Bando Eco Apparels Ltd.

21st November 2017

Observations

Discrepancies between provided drawings and on site condition

Column layout plan

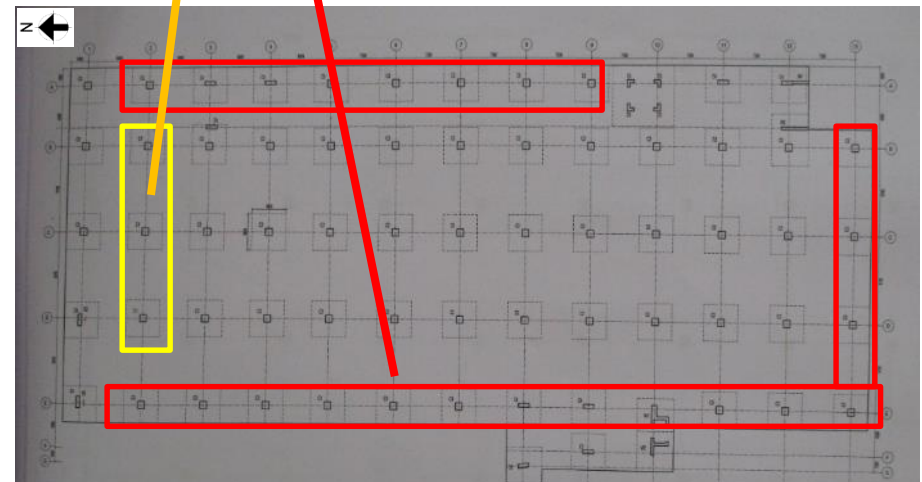
Reinforcement detected by Ferro Scanning internal and external columns in Production Building (Building-1) appears to be different than shown in the structural drawings. Building engineer to verify number and diameter of rebars at least at two sides by removing plaster and concrete cover at typical columns before commencing future construction.

Observed by ferro scan at Ground Floor

28 rebars
(8 rebars on each face)

24 rebars
(7 rebars on each face)

Details of shear wall

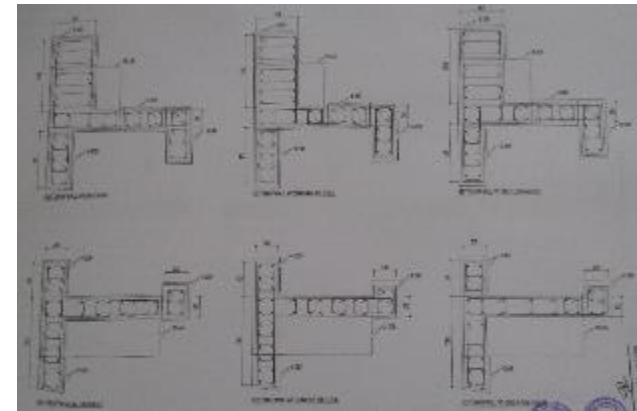
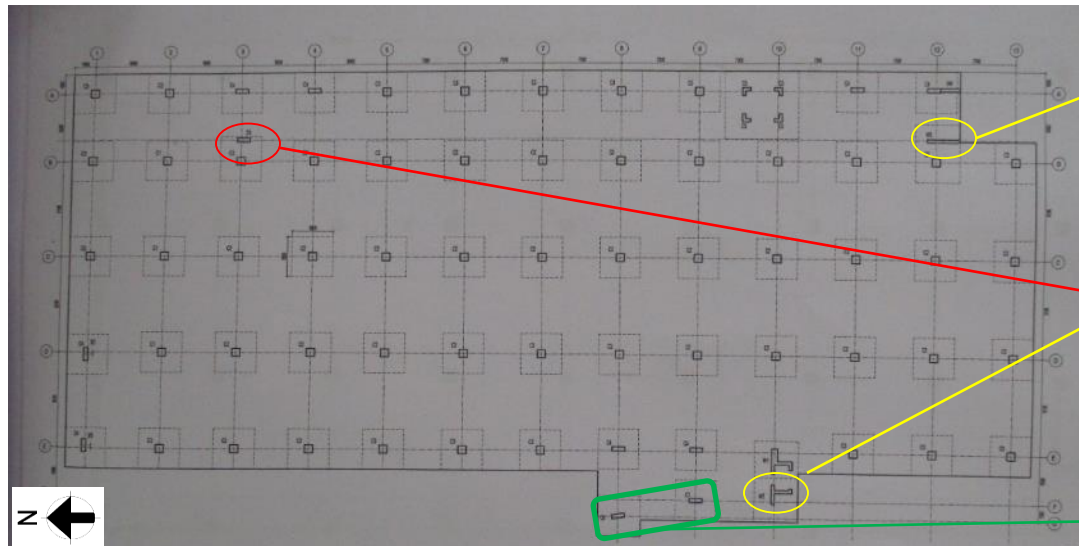
No details were found in column schedule for C6 & C7 type column. Size & number of rebar of shear wall didn't match with provided drawings. On grid-3 an extra column was found. No foundation system is shown on drawings for the additional column. So the load path and foundation system of the extra column is required to be investigated by the factory engineer.

Shear wall

C-6 & 7 Column

Extra Column

Floor load plan of Building-1

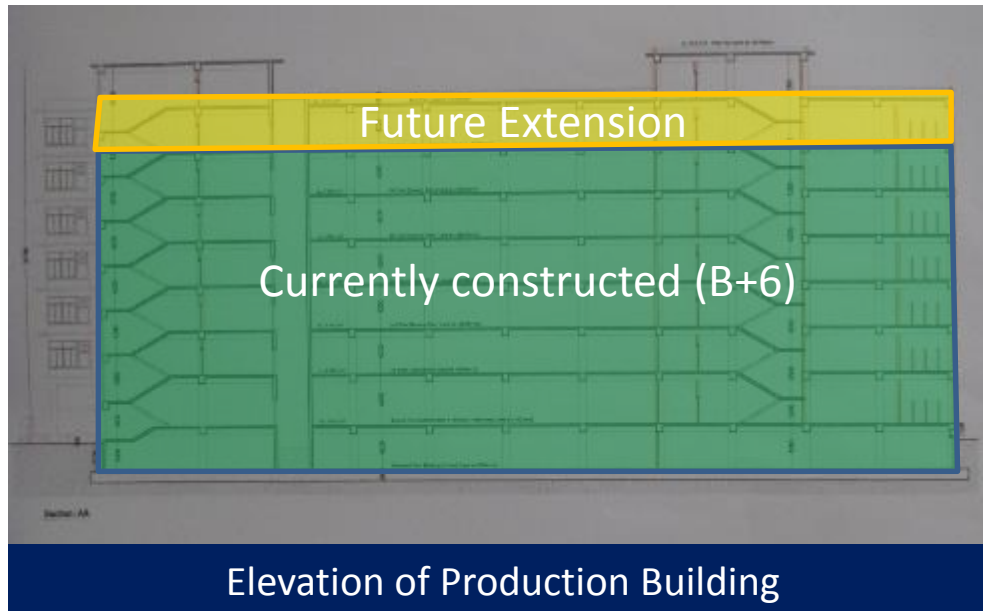
Factory engineer has prepared design report for Building-1 (B+7) considering maximum 6 kpa allowable floor live load. Compressive strength (f'_c) of column concrete considered 5000 psi in FEM model but no concrete cylinder test report for column was shown. Factory engineer to be verified in-situ concrete strength for columns and revise the design report following BNBC provision. Factory is required to maintain the floor live load maximum 3kpa until completion of revised design report.

During inspection over loading was not observed and FoS calculation for internal column was found satisfactory considering 3 kpa allowable floor live loading.

Column Layout

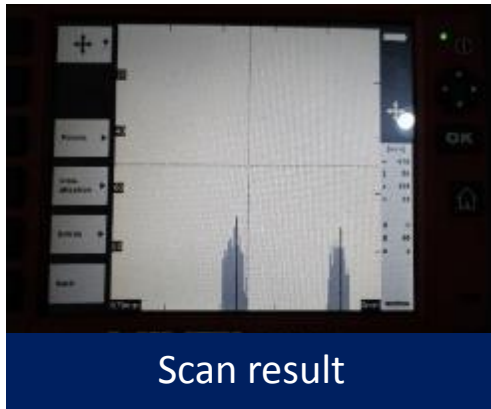
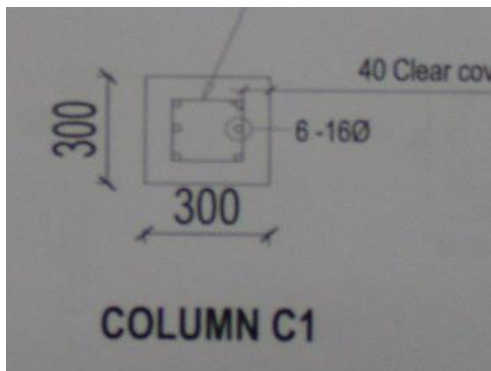
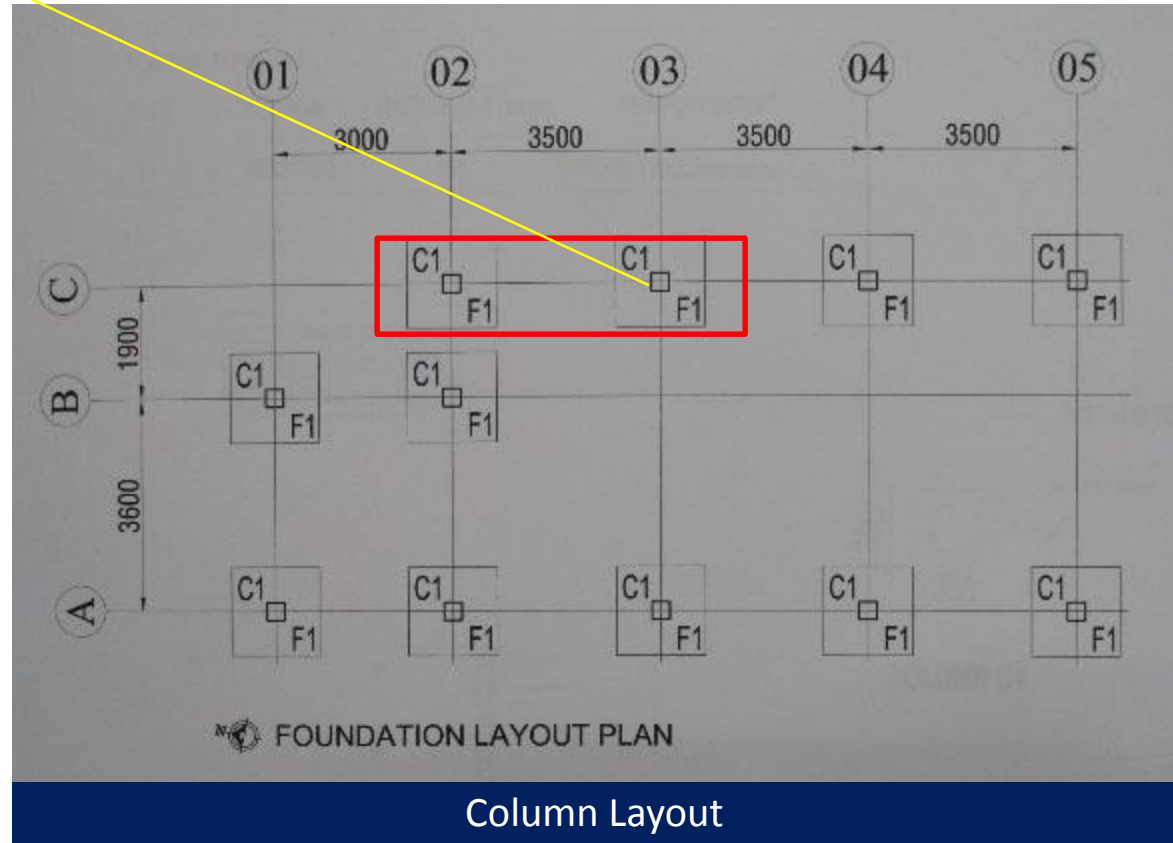
Number of rebar at corner column didn't matched with as-built condition. 6 number of rebar were shown in column schedule whereas 4 rebar were found by ferro scanning.

6	(Production building) Future extension to be carried out	In case of extension, factory engineer to be carried out further analysis and update design report following BNBC requirement.	6-weeks
7	(Health & Child care) Mismatch in drawings	Prepare update as-built documentation confirming rebar details for Health & Child care.	6-weeks
